**DEVELOPMENT REVIEW COMMITTEE
AGENDA
REGULAR MEETING
City Hall – Council Chamber
405 Bagshaw Way, Edgewood, Florida
Tuesday, February 4, 2020
10:00 a.m.**

HOLDEN AVENUE PD DEVELOPMENT PLAN

**DRC February 4, 2020
HOLDEN AVENUE PD
Planning Comments of January 24, 2020**

C300

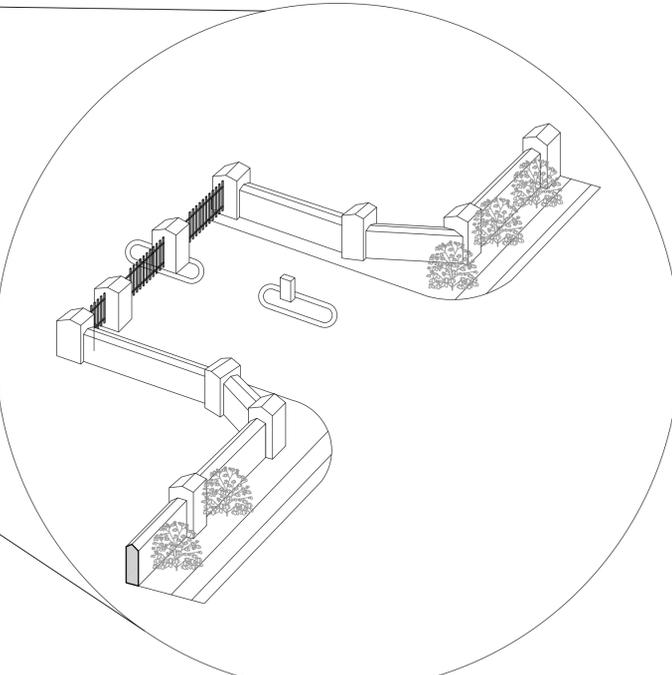
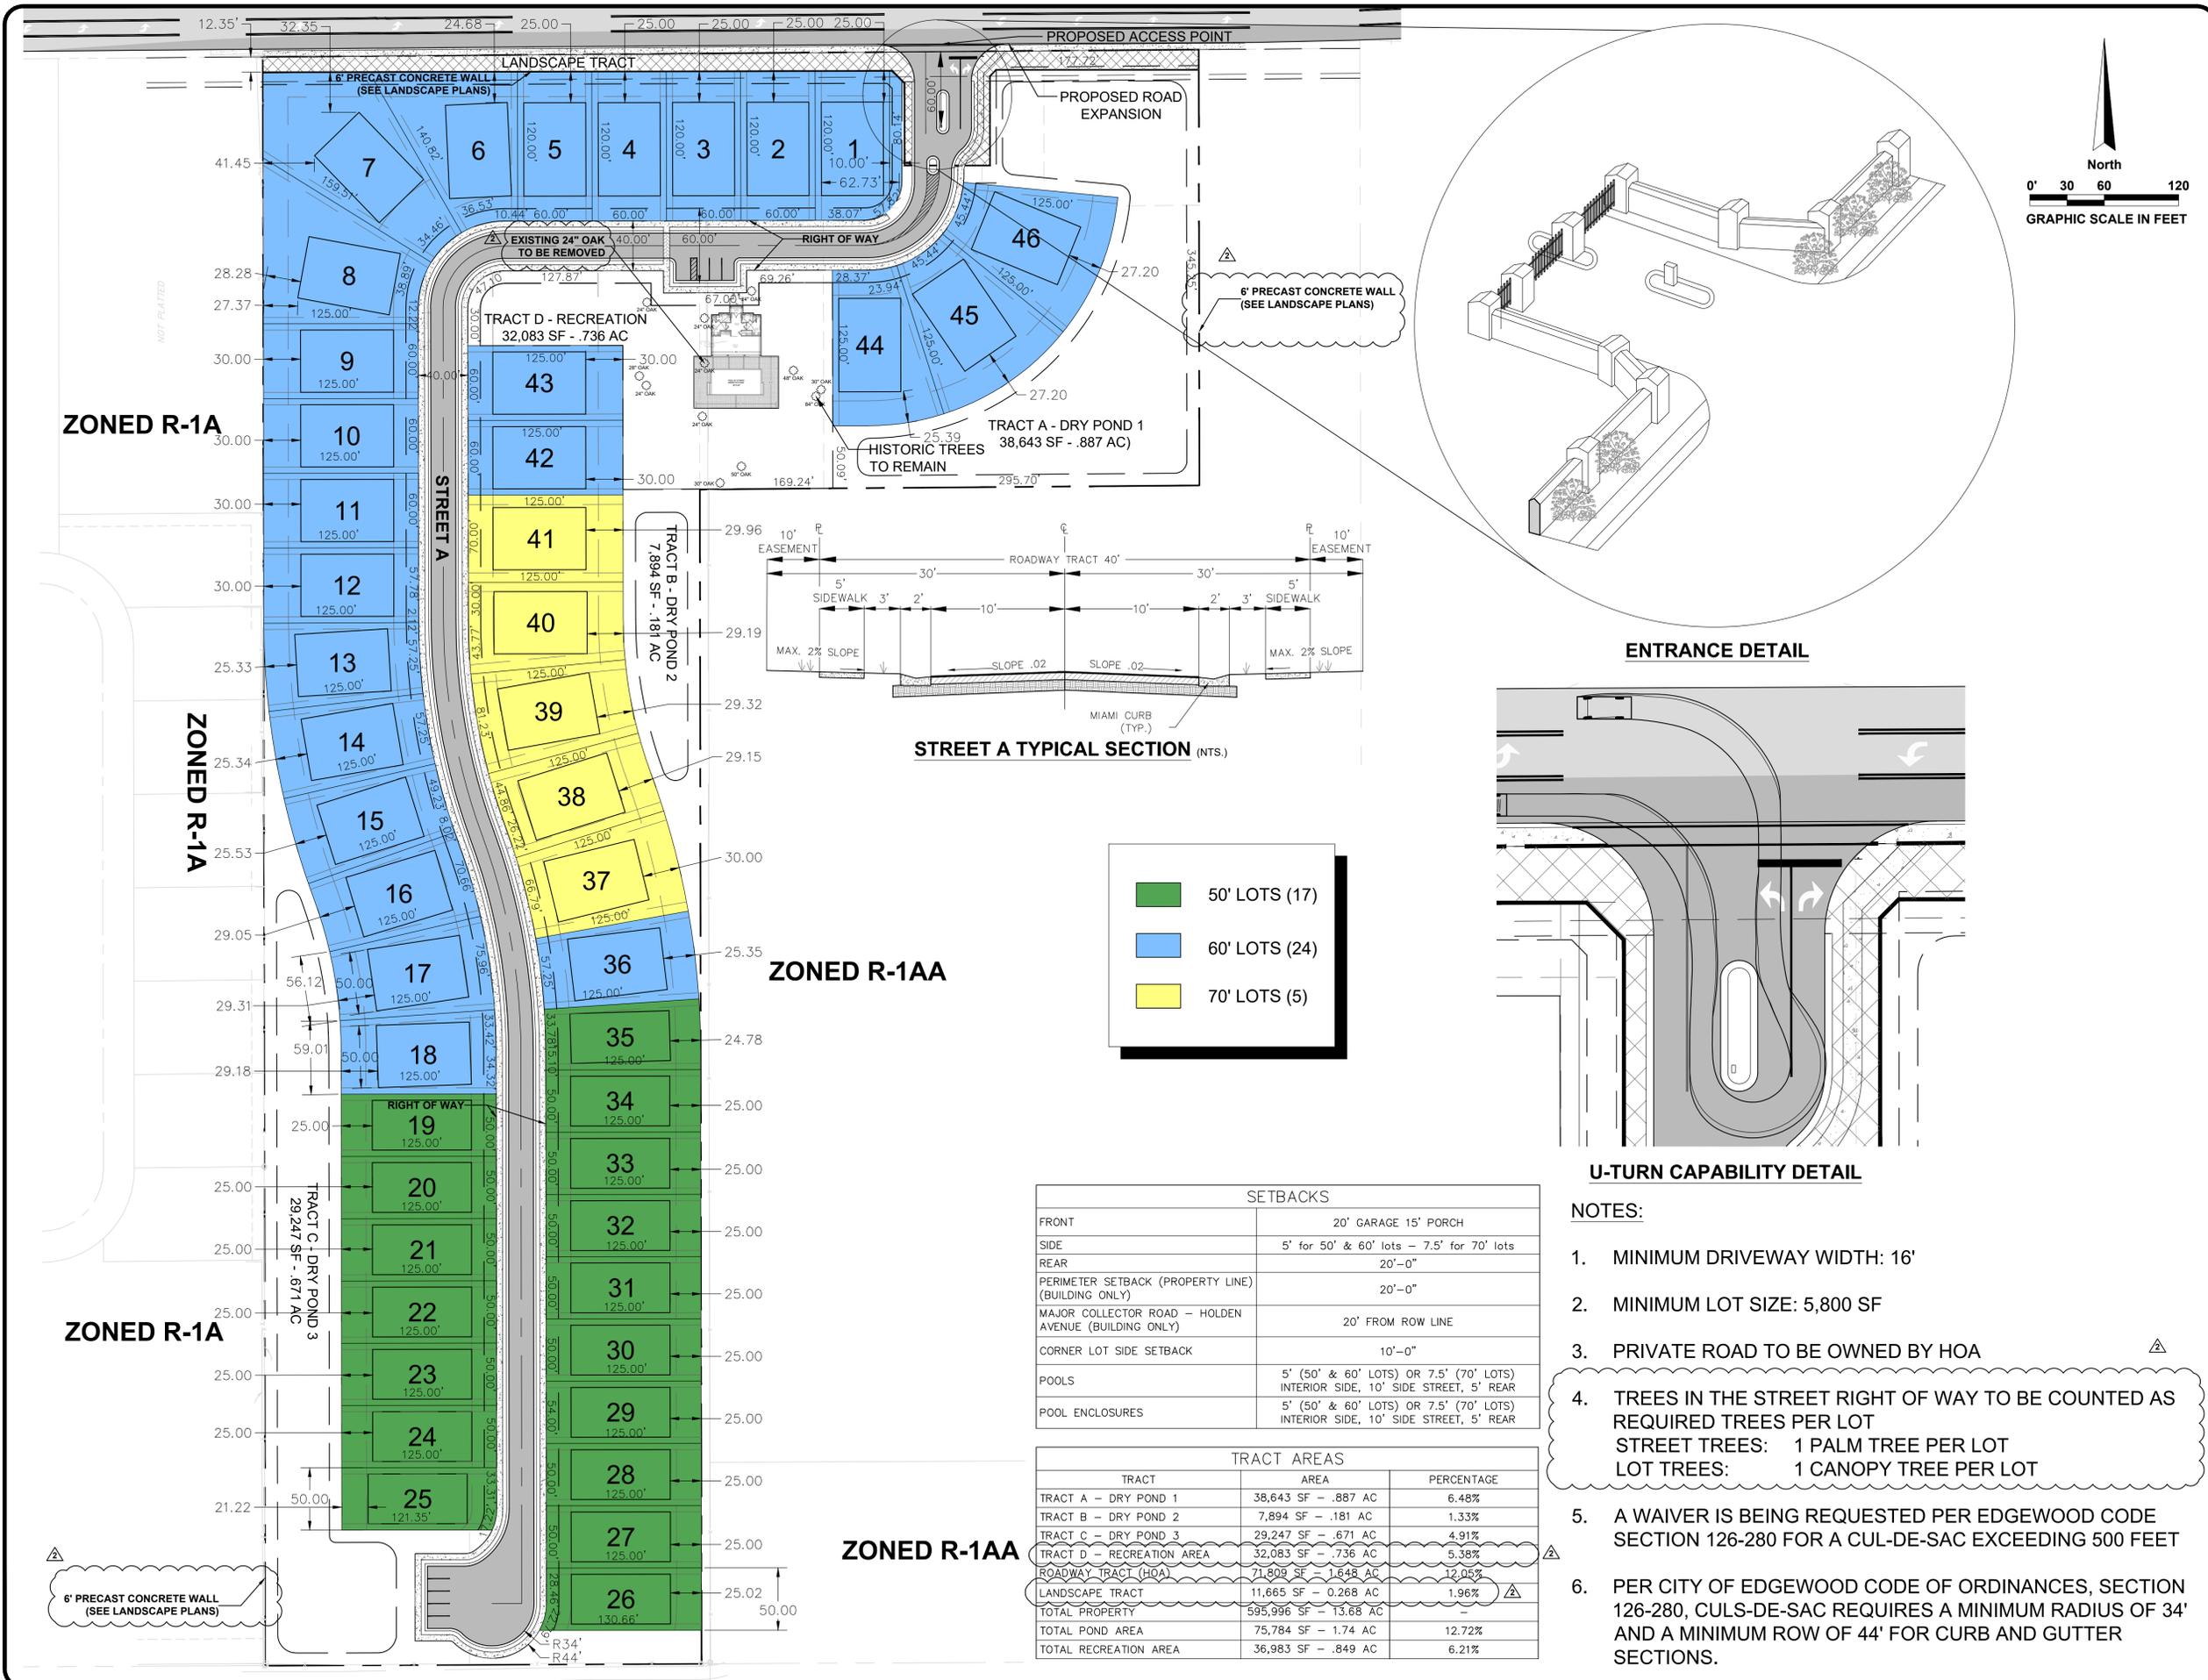
16. What is the correct acreage for the Recreation Area of Tract D? Sheet C301 identifies the tract as .670 (on the tract), while Sheet C300 identifies the area as 0.54 acre.

1. Code Section 134-460(7) requires the PD Land Use Plan to identify major street setbacks. Revise the table on Sheet C300 to reflect that Holden Avenue is classified as an Urban Minor Arterial with the correct major road setback. The requirement is a minimum 60 feet from centerline (c/l) for all structures. Staff does not support disregarding the major road setback as required by Code Section 126-223.

5. The comments on the previously submitted plans referenced an inconsistency with Code Section 134-484(g) that prohibits structures in all districts from being erected closer than 15 feet from a side street lot line or any intersecting street right-of-way. The design of the subdivision has been revised, but the table on sheet C300 has not. Please resolve the conflict.

Response: Sheet C300 has been updated to show the required and provided recreation areas. The recreation tract consists of .736 acres

C401

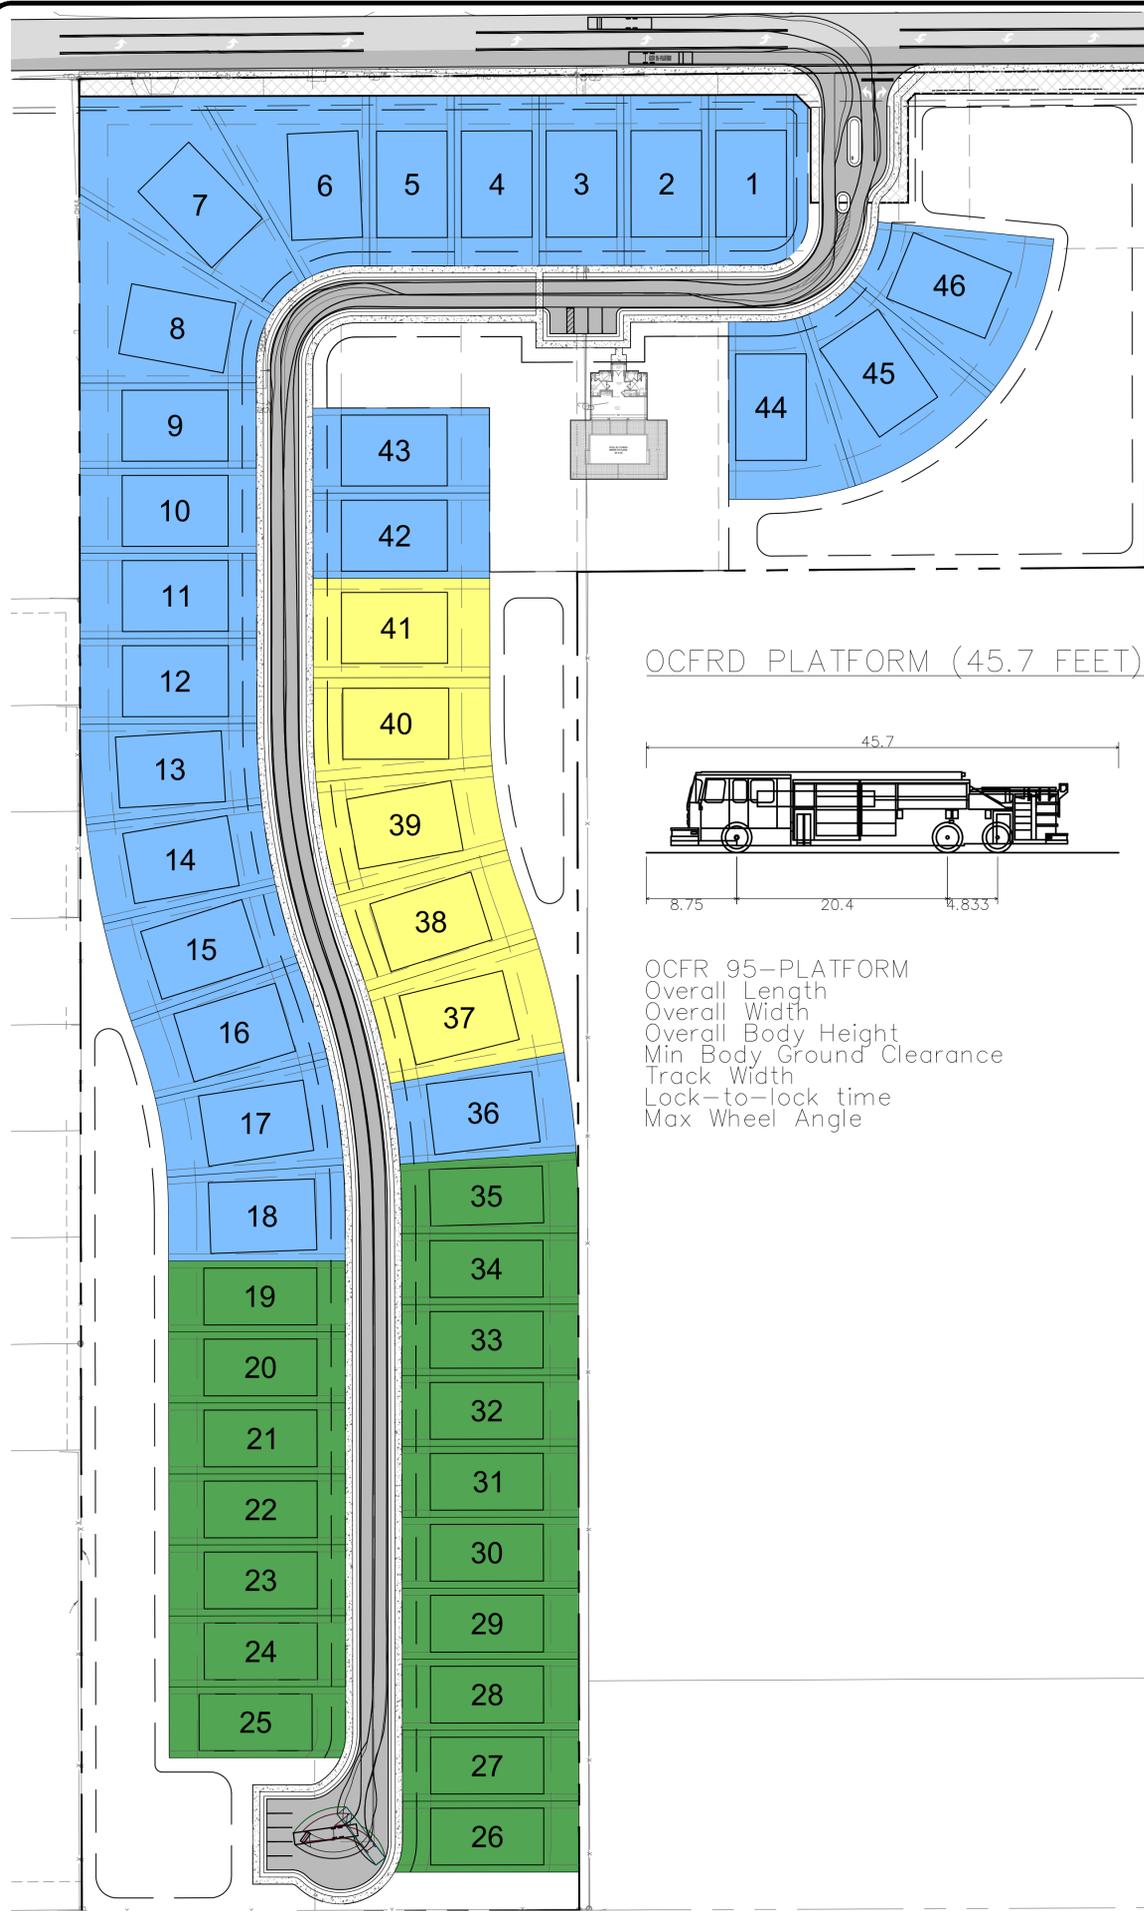
9. What is the available vehicle queue length (feet) between the call/code box and the property right-of-way line? The minimum recommended by staff is 60 feet. The 85.82-foot dimension on Sheet 400 appears to be from the gate (not call box) and the Holden Avenue pavement. The queue length needs to be measured from the call box to the property/right-of-way line.

- a. Please provide that referenced confirmation from the Orange County Fire Department.
 - b. Sheet C400 appears to show two 9 feet wide lanes, for a total of 18 feet each, not 20 feet. Furthermore, the entrance lanes narrow to even less than 18 feet south of the call box/gate. Please identify the width at the gate. State fire marshal requirement is at least 20 feet of unobstructed width.

Response: A total of 60' has been provided for the queue length, from the call box to the property line.

Exhibit 1

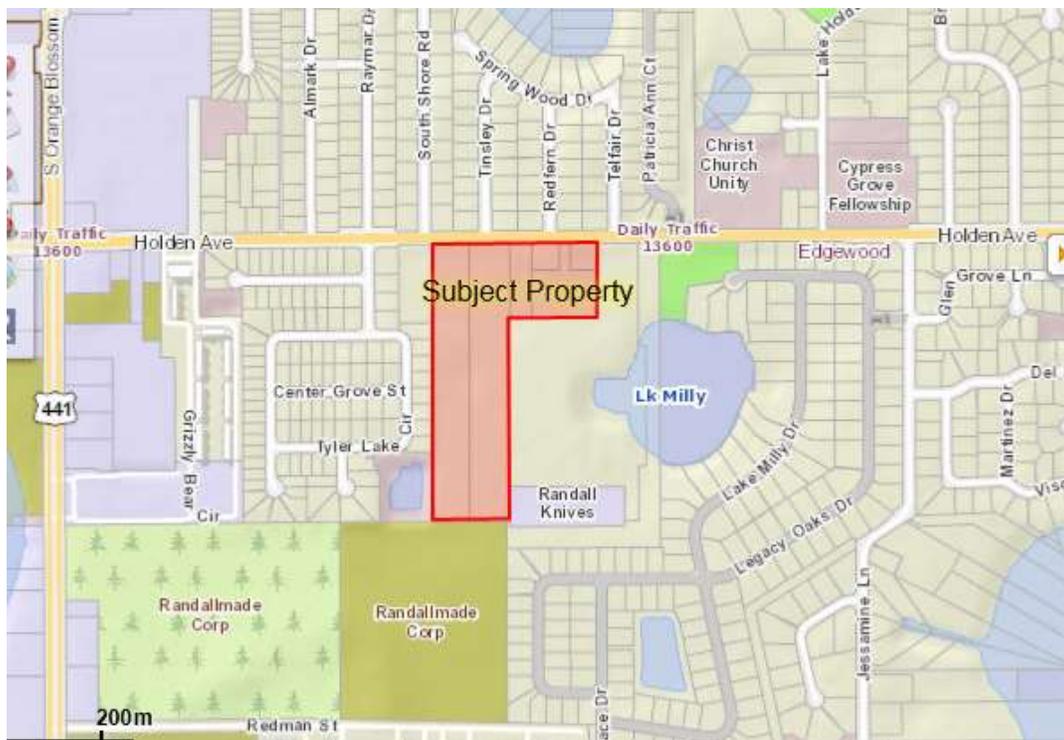
The purpose of the DRC meeting is to discuss the proposed land use plan dated January 2, 2020 for the following current tax parcels, which are located on the south side of Holden Avenue; the boundary is shown in Exhibit 1.
